UNITED STATES PATENT AND TRADEMARK OFFICE

10/087,728 02/28/2002 Evan D.H. Green NUFO021CON 7513

Office Action Summary

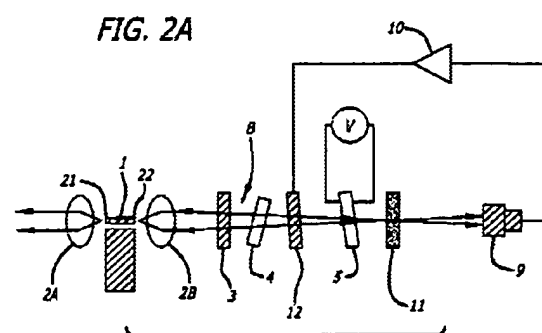
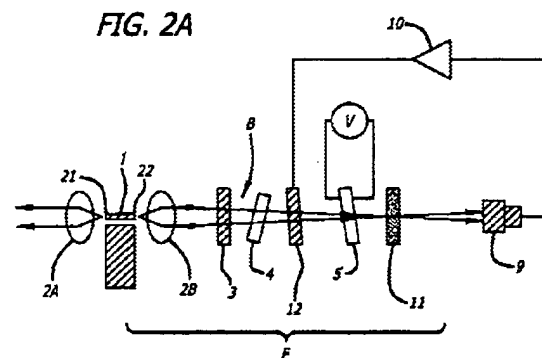
10. Claim 1 is rejected under 35 U.S.C. 102(e) as being anticipated by Avrutsky et al. (6141370). Avrutsky et al. teach a tunable

filter apparatus **Fig. 7**, comprising a grid

generator **72** positioned in an optical path

and configured to generate a first set of

transmission peaks corresponding to

channels of a selected wavelength grid, **see**

col. 7, lines 36-39 and Fig 8A; and a channel selector **74** positioned in the optical path

and configured to generate a second set of transmission peaks, **see col. 7, lines 39-40**

and Fig. 8B.
